Stationary Gas Turbines

Standard Support and Environmental Impact Statement Volume II: Promulgated Standards of Performance

Publication No. EPA-450/2-77-017b

1. SUMMARY

Figure 2-1. Controlled NO_x emission levels vs fuel-bound nitrogen level

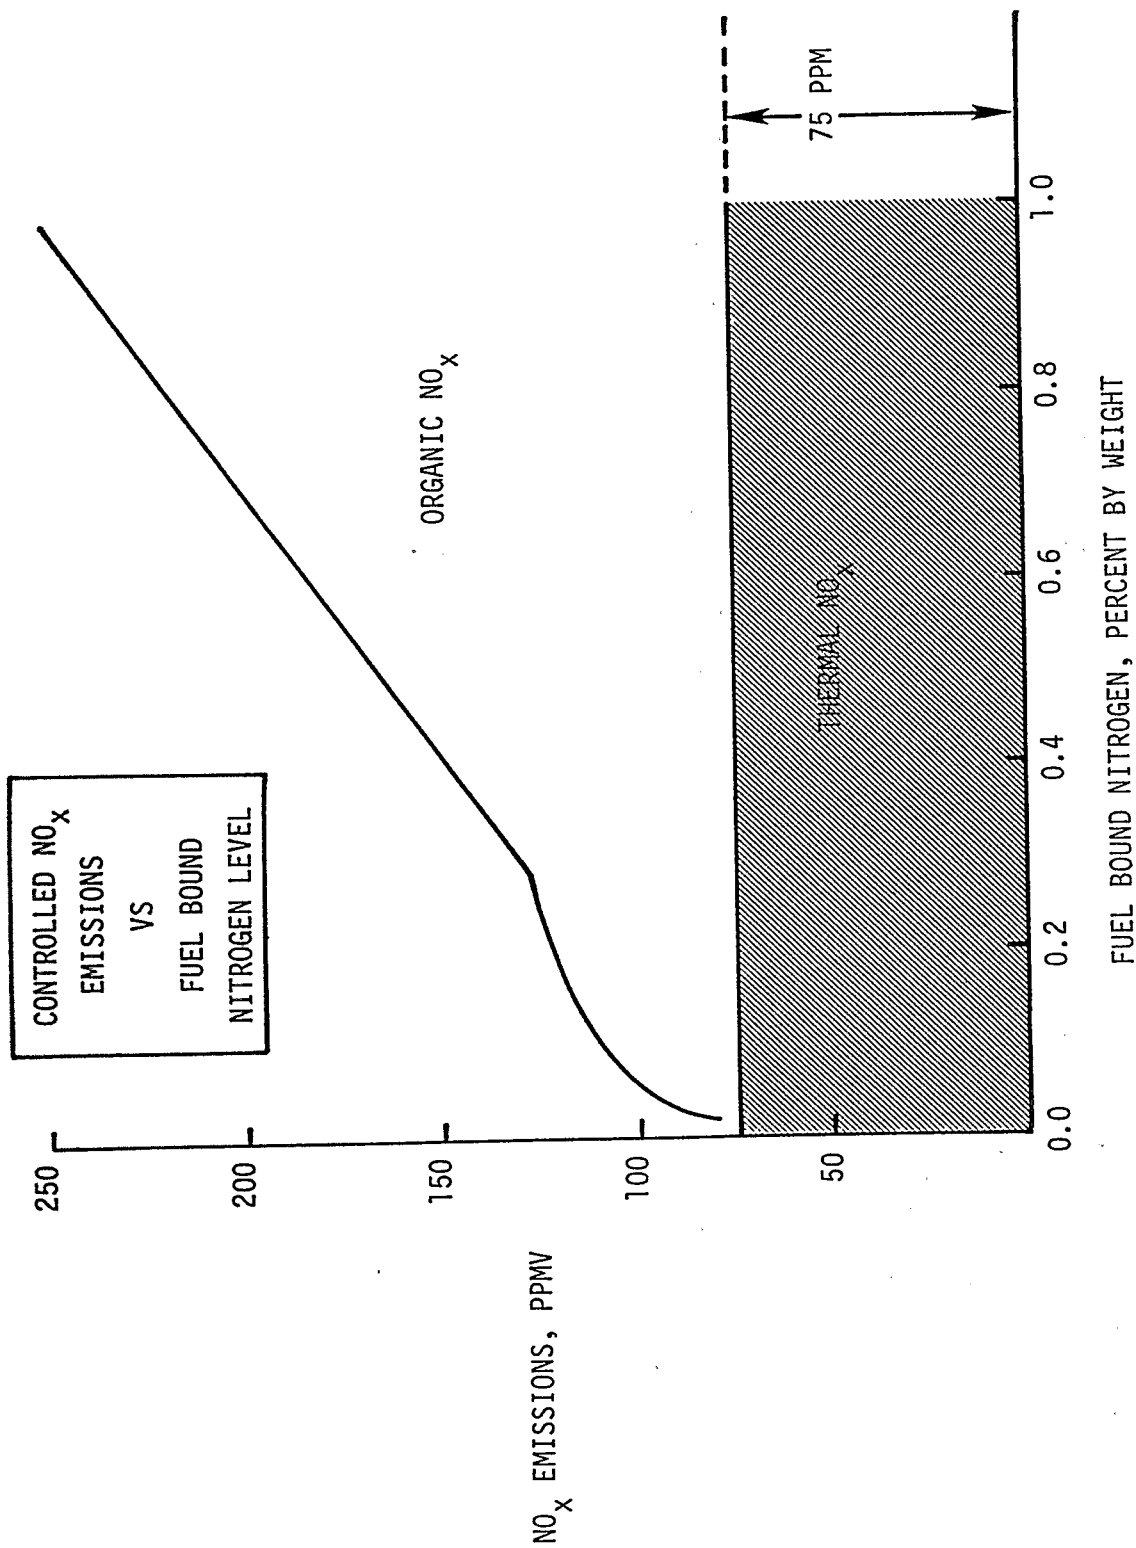
A number of writers commented on the potential impact of the standards on the use of shale oil, coal-derived, and other synthetic fuels. It was generally felt that these types of fuels should not be covered by the standards at this time, since this could hinder further development of these fuels. Commenters recommended that EPA wait until such fuels are available and being fired successfully in gas turbines and then set the fuel-bound nitrogen allowance for these fuels based on actual data.

As fuel-bound nitrogen increases, the organic NO_x emissions from a gas turbine with thermal NO_x control become a predominant fraction of total NO_x emissions (See Figure 2-1). Consequently, the standards must address in some manner the increased NO_x emissions caused by fuel-bound nitrogen. Since NO_x emission control technology is not effective in reducing organic NO_x emissions from gas turbines, the possibility of basing standards on removal of nitrogen from the fuel prior to combustion was considered as an alternative. The cost of removing nitrogen from the fuel ranges from \$2.00 - \$3.00 per barrel. Nitrogen removal from the fuel, therefore, is not considered reasonable, as the basis for standards of performance.

A limited fuel-bound nitrogen allowance which would allow NO_x emissions above the NO_x emission standard is most reasonable. An upper limit of 50 ppm NO_x was selected because such a limit would allow approximately 50 percent of existing heavy fuel oils to be fired in stationary gas turbines (for a more detailed discussion of the fuel-bound nitrogen allowance the reader is referred to Volume I, Chapter 8 of the SSEIS). The fuel-bound nitrogen allowance is considered a reasonable means of allowing flexibility in the selection of fuels while retaining effective control of total NO_x emissions from stationary gas turbines.
